dsPIC33EPXXXGP50X, dsPIC33EPXXXMC20X/50X and PIC24EPXXXGP/MC20X Family Silicon Errata and Data Sheet Clarification

The dsPIC33EPXXXGP50X, dsPIC33EPXXXMC20X/50X and PIC24EPXXXGP/MC20X family devices that you have received conform functionally to the current Device Data Sheet (DS70000657H), except for the anomalies described in this document.

FIGURE 1: TIMING DIAGRAMS FOR CENTER-ALIGNED AND EDGE-ALIGNED MODES

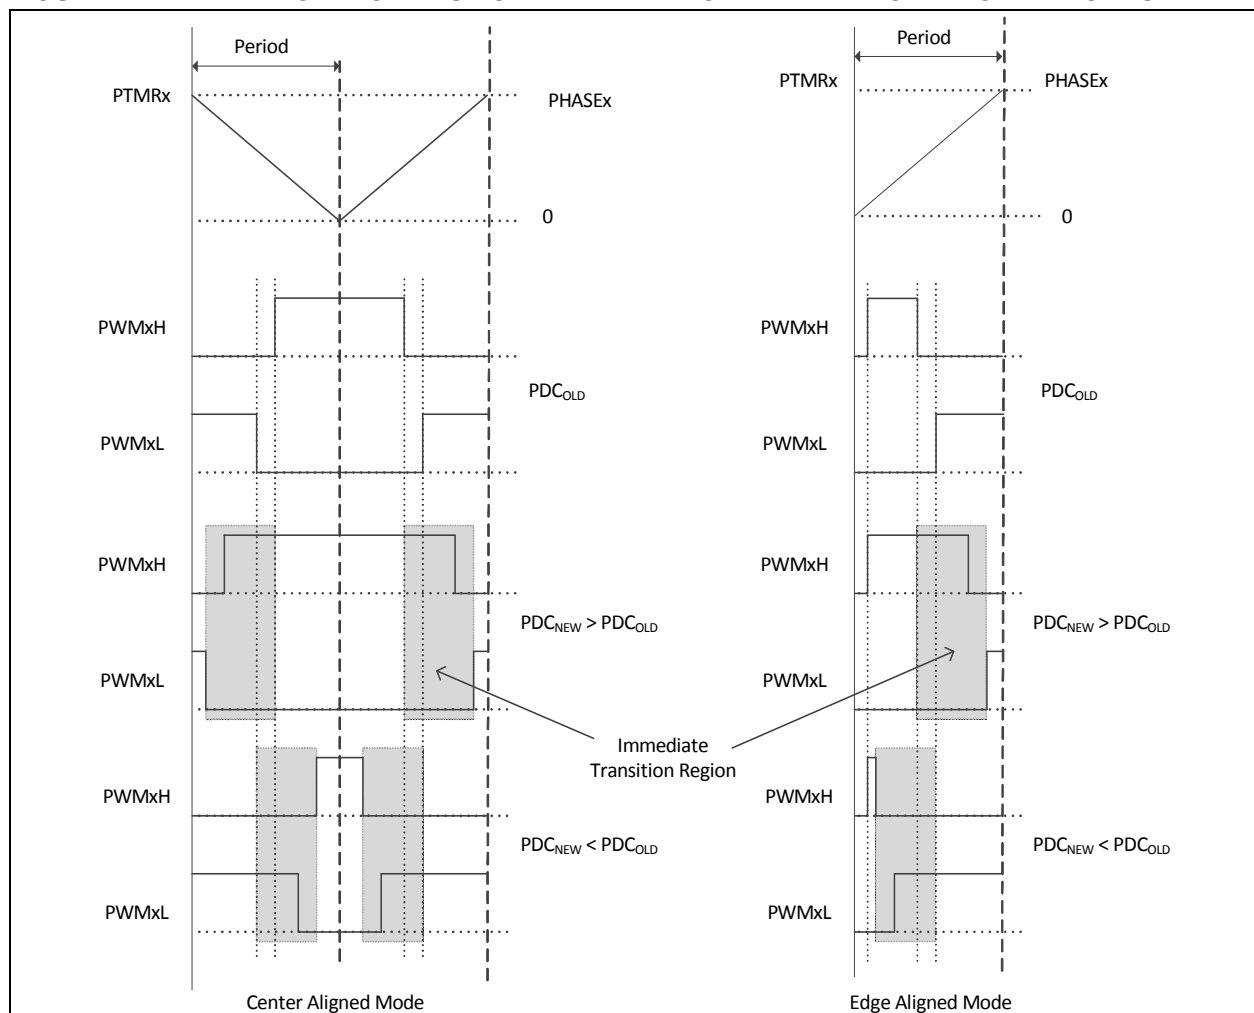
The PWM generator may not assert dead time on the edges of transitions. This has been observed when all of the following conditions are present:

- The PWM generator is configured to operate in Complementary mode with Independent Time Base (ITB) or master time base;
- Immediate update is enabled; and
- The value in the PDC register is updated in such a manner that the PWMxH and PWMxL outputs make an immediate transition.

In [Figure 1](#), if the duty cycle write occurred in the shaded box, then PWMxH and PWMxL will make an immediate transition without dead time.

However, in most applications the duty cycle update timing can be controlled using the TRIGx trigger, or Special Event Trigger, such that the above mentioned conditions are avoided altogether.

FIGURE 2: PWM TIMING DIAGRAM

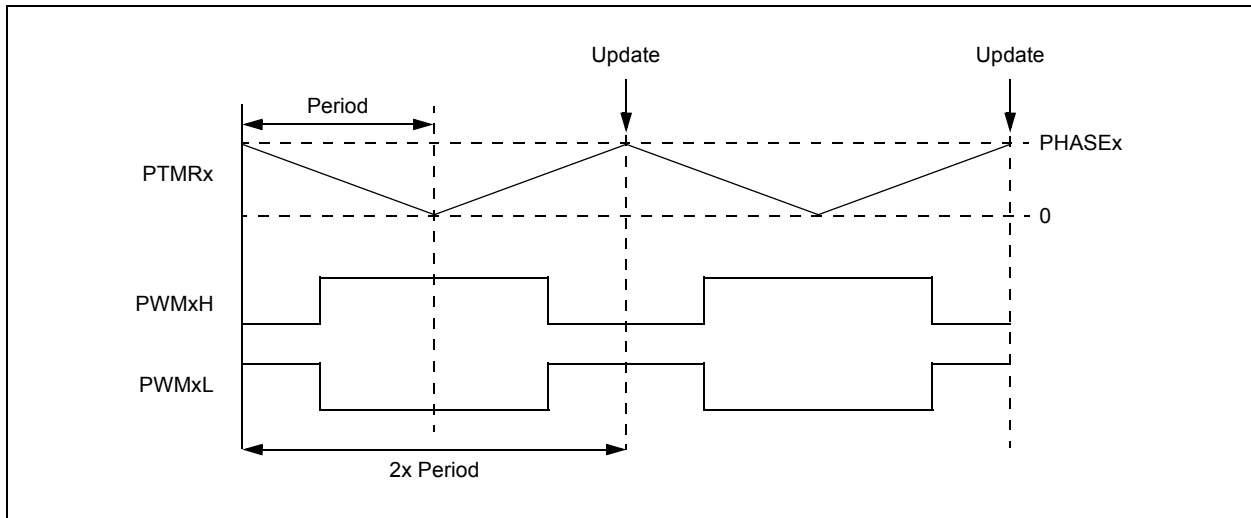
In Center-Aligned mode, updates to active MDC/PDCx/ALTDTRx/PHASEx registers occur only once every two PWM periods; that is, when the PWM timer matches the PHASEx register. In other words, the double update feature is not available. Figure 2 illustrates this relationship.

FIGURE 3: CORRECT AND INCORRECT POSITION COUNT CAPTURES

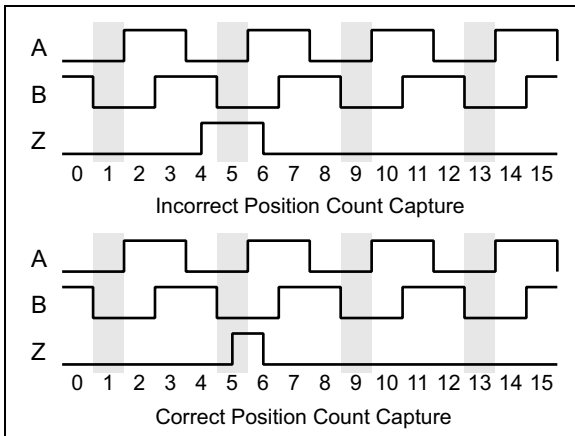
When index count position capture is being used (QEIXOC.QCAPEN = 1), the position count may be one more or one less than the correct value, depending on the direction of the count.

This is only observed when the leading edge of the index pulse occurs prior to the leading edge of the index match event. When the index pulse starts after the leading edge of the index match event, the position count is captured correctly.

Figure 3 shows how this occurs. In these cases, Encoder Signals A, B and (index) Z are shown, with the module being configured for index match when A and B are '0'. The effects of a correct and incorrect capture are shown side by side (shaded area indicates the index match event); the position count is shown along the bottom.

For encoder signals with timing that ensures the index pulse always starts prior to the start of the index match event (i.e., encoders with a non-gated index pulse), measure the direction of the encoder motion. If the encoder is counting up, add one to the captured position count; if the encoder is counting down, subtract one from the captured position count.

For encoder signals where the index pulse leading edge approximately coincides with the start of the index match event (i.e., encoders with a gated index pulse), a small delay can be added to the index pulse, for instance, by using a simple R-C filter.

FIGURE 4: PWM GENERATOR TIMING DIAGRAM

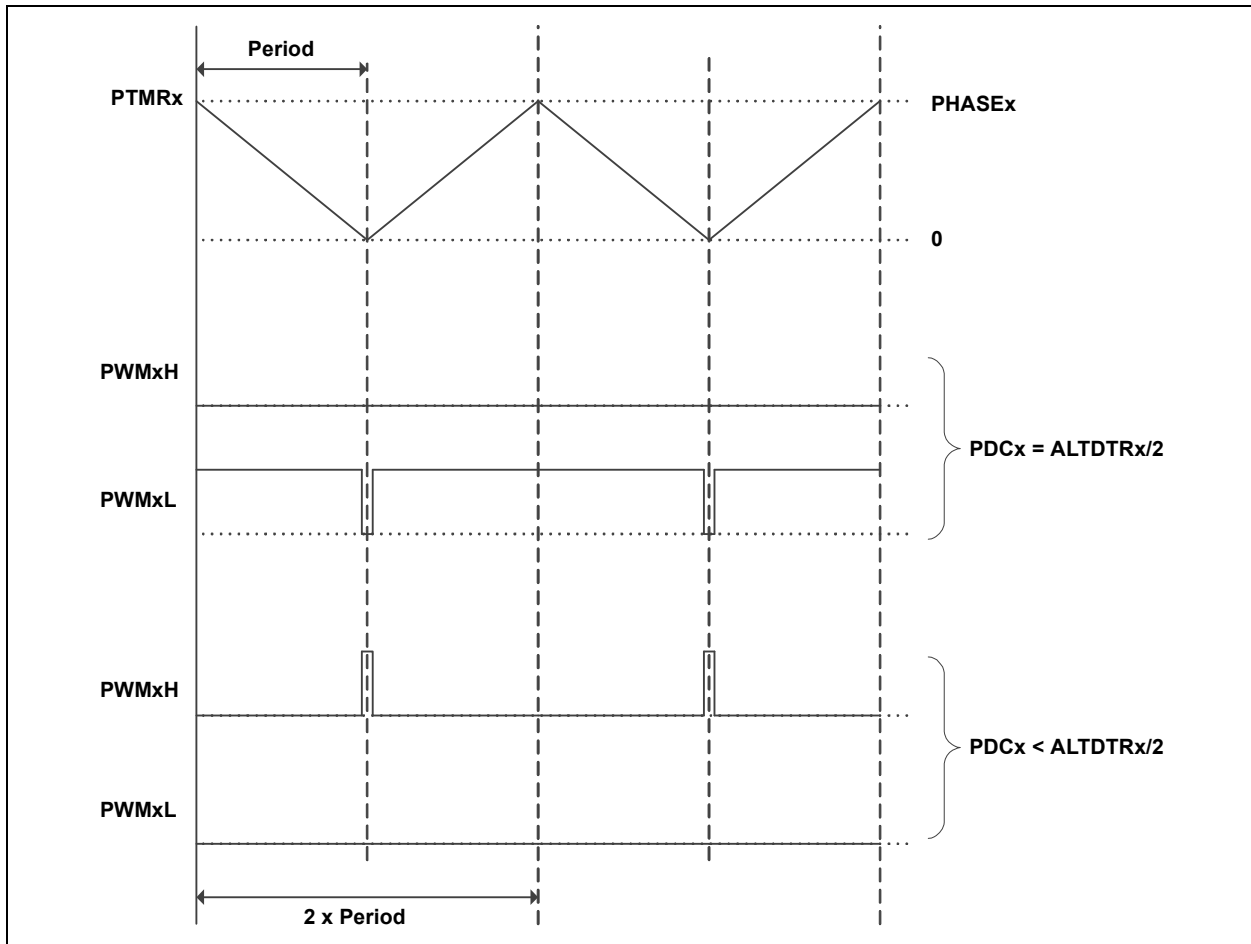
In Center-Aligned Complementary mode with Independent Time Base, if the value in the PDCx register is less than one-half the value in the ALTDTRx register, the PWM generator will force the PWMxL to low, and on the PWMxH, generate pulses of width less than twice the dead time, as shown in Figure 4.

FIGURE 5: ILLUSTRATION OF 1 T_{osc} GLITCH WHEN PWM OVERRIDE IS TURNED OFF

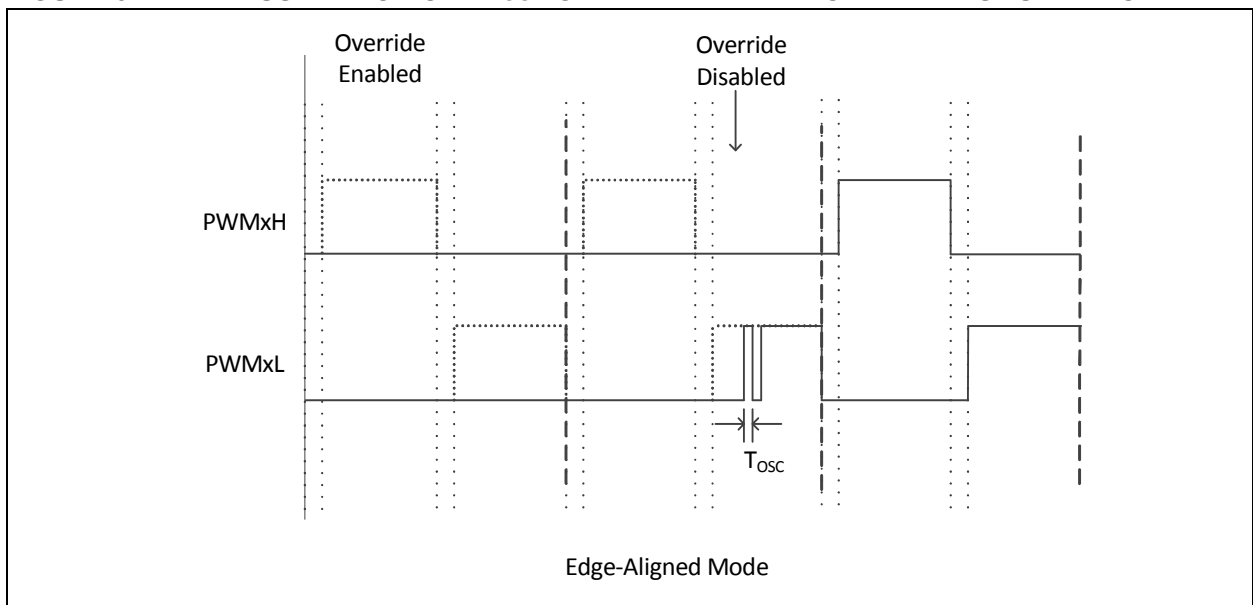
In Complementary mode after the PWMx module is enabled (PTEN = 1), if the PWM override is turned off, a 1 T_{osc} glitch will be present on the rising edge of either PWMxH or PWMxL, whichever occurs first, as shown in Figure 5. The glitch will be present on PWMxH/PWMxL every time the override state is changed from enabled to disabled. The width of this glitch is equal to 1 T_{osc} when PCLKDIV<2:0> = 000; increasing the PWM input clock prescaler setting will increase the width of the glitch accordingly.

FIGURE 6:

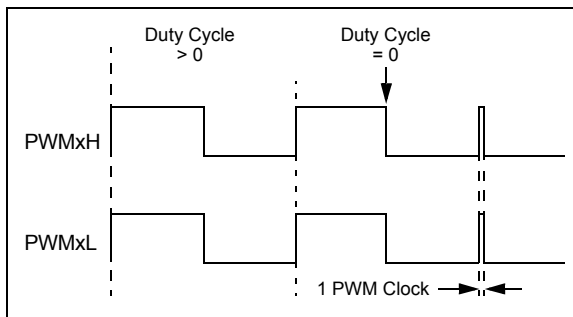
In certain output modes, the PWMx module produces a pulse glitch of one PWM clock in width (Figure 6). This has been observed only when all of the following are true:

- Either Redundant or Push-Pull Output mode is selected (IOCONx<11:10> = 10 or 01);
- Immediate Update is disabled (PWMCONx<0> = 0); and
- The value of the current Duty Cycle register (either the PDCx or MDC register, as determined by PWMCONx<8>) is updated to zero from any non-zero value.

The pulse glitch has been observed to occur at the beginning of the following PWM boundary period.

FIGURE 7:

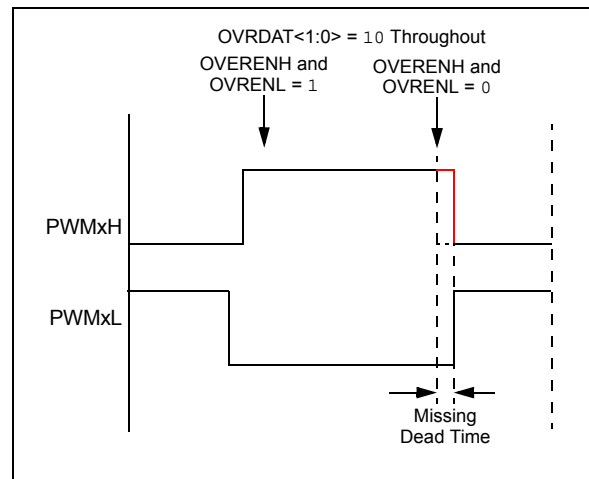
- Output override synchronization is configured to occur on the CPU clock boundary (IOCONx<0> = 0);
- Both PWMxH and PWMxL overrides are enabled prior to the event (OVRENH and OVRENL are both '1'), and
- Both overrides are disabled (OVRENH and OVRENL are both '0') at the instant the dead time should be asserted (Figure 7).

This has been observed in both Center-Aligned and Edge-Aligned modes.

FIGURE 8:

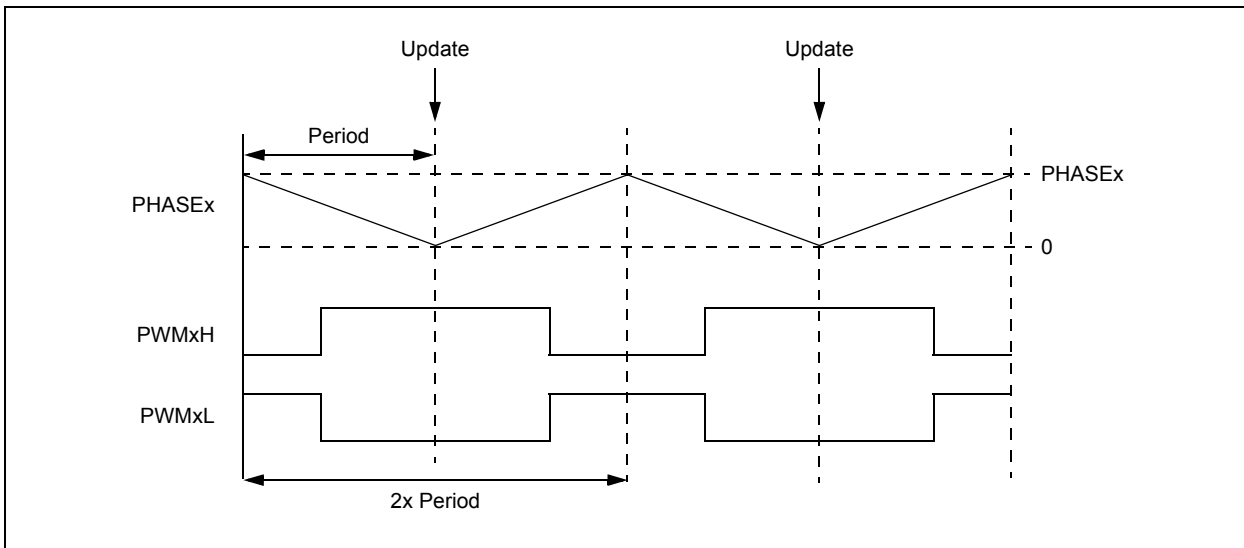
In Center-Aligned Complementary mode with Independent Time Base, updates to the PHASEx register take effect in the middle of a center-aligned PWM cycle, as shown in Figure 8. This occurs only when the Immediate Update feature is disabled (IUE = 0). If Immediate Update is enabled (IUE = 1), the PHASEx register updates will take effect immediately.

FIGURE 9: SIMPLIFIED BEHAVIOR

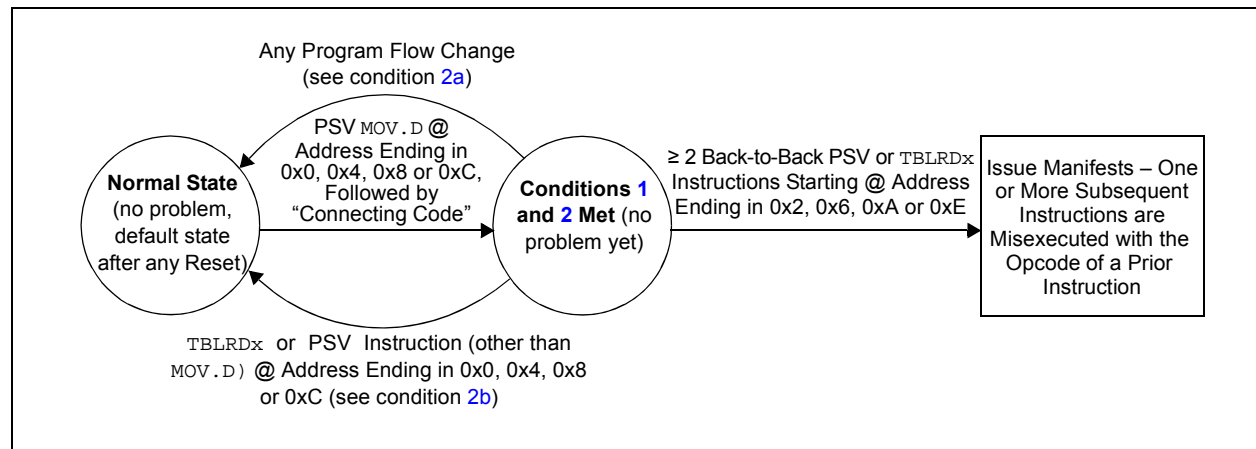
3.	≥ 2 back-to-back PSV or TBLRDx instructions are executed (following the code of condition 2), where the first of the back-to-back instructions is located at an address ending in 0x2, 0x6, 0xA or 0xE.

Figure 9 provides an example of the effective behavior.

1. All instances of PSV `MOV.D` can be replaced with two PSV `MOV` instructions instead. Non-PSV `MOV.D` instructions acting on RAM/SFRs do not need to be modified; or
2. If not already present, a program flow change instruction (such as `BRA $+2`) can be inserted above back-to-back data Flash read sequences; or
3. Back-to-back data Flash read instruction sequences can be broken up by inserting a non-Flash read instruction (such as a `NOB`) in between the Flash read instructions; or
4. The alignment of the code can be shifted to avoid the required opcode location addresses.

FIGURE 32-10: TYPICAL LPRC FREQUENCY @ VDD = 3.3V

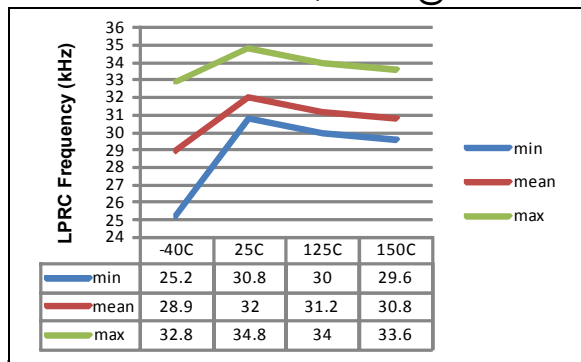
The typical LPRC frequency plot over temperature at VDD = 3.3V has been corrected, as shown in Figure 32-10 below.

FIGURE 25-1: OP AMP/COMPARATOR x MODULE BLOCK DIAGRAM (MODULES 1, 2 AND 3)

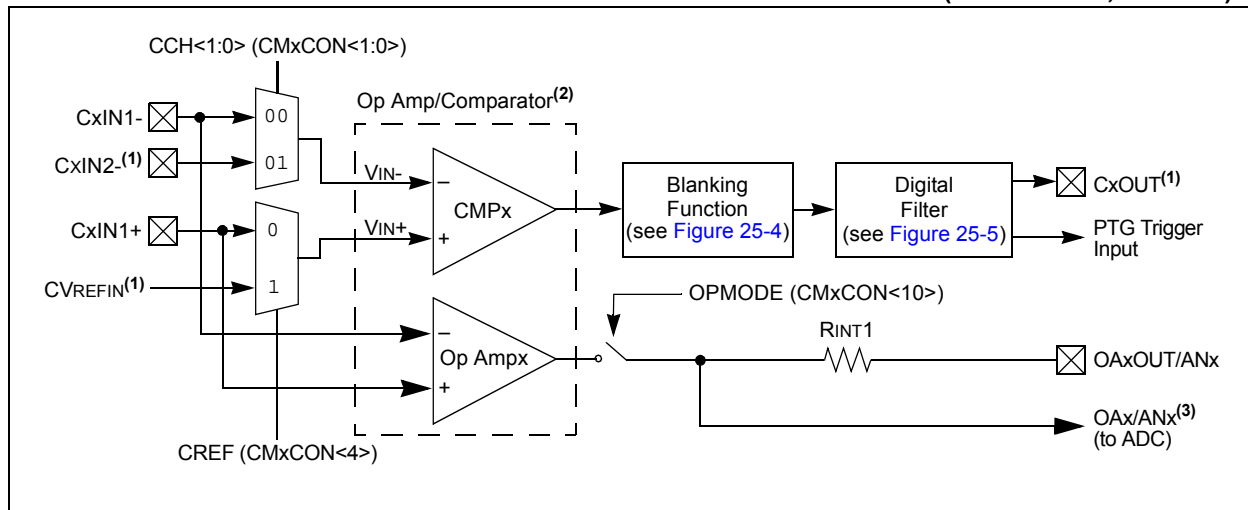
Figure 25-1 (shown below) is corrected to show that the op amp in these modules obtains its inverting and non-inverting inputs directly from the CxIN1-/1+ pins. The operation of the actual module is unchanged. (Footnotes in the original are unchanged, but are removed here for clarity.)
